<p>DO NOT SCALE THIS DRAWING</p>		<p>USED ON</p>		<p>REV</p>		<p>DATE</p>		<p>200CFM, BACK TO AIR CART, ASSY CHAMBER RE-PRESSURIZATION SYSTEM</p>	
<p>REFERENCE DRAWINGS</p>		<p>DESCRIPTION</p>		<p>ISSUE DESCRIPTION</p>		<p>CHGD DRWN DATE DEC#</p>		<p>LIGD VACUUM EQUIPMENT</p>	
<p>DWG. NO.</p>		<p>DESCRIPTION</p>		<p>ISSUE DESCRIPTION</p>		<p>SCALE NONE</p>		<p>SHEET 1 OF 1</p>

L190-D970363-01-V

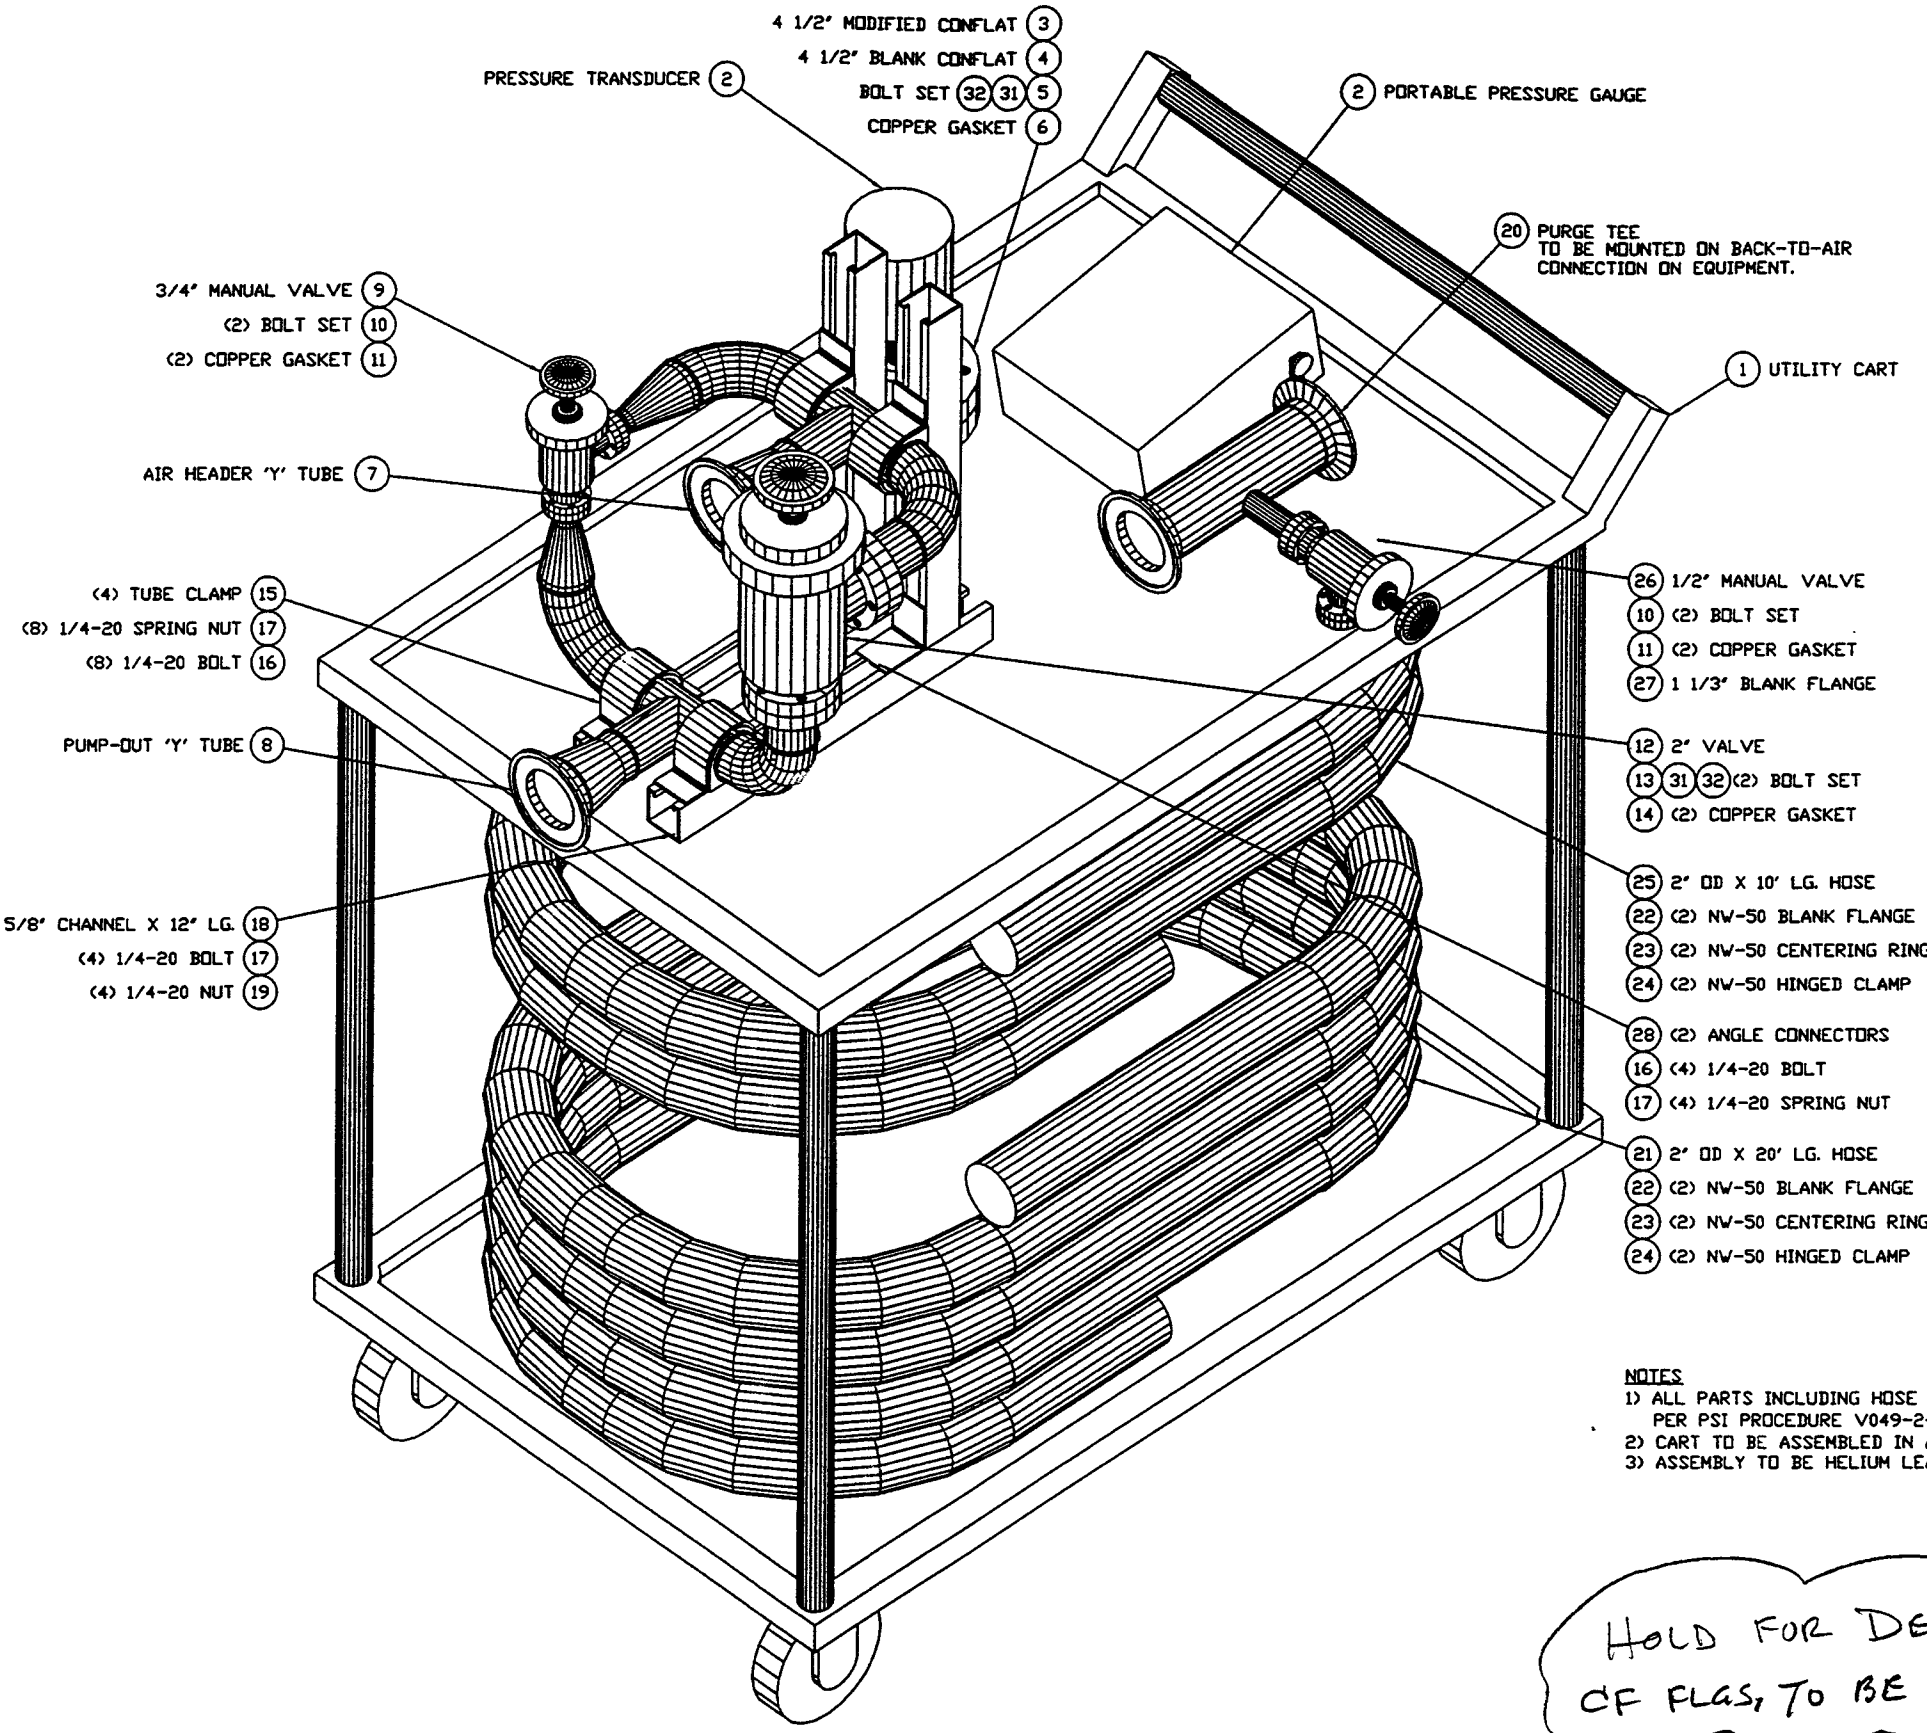
*HOLD FOR DESIGN CHANGE, VALVE CF FLAS, TO BE ISO QUICK FLANGES,*
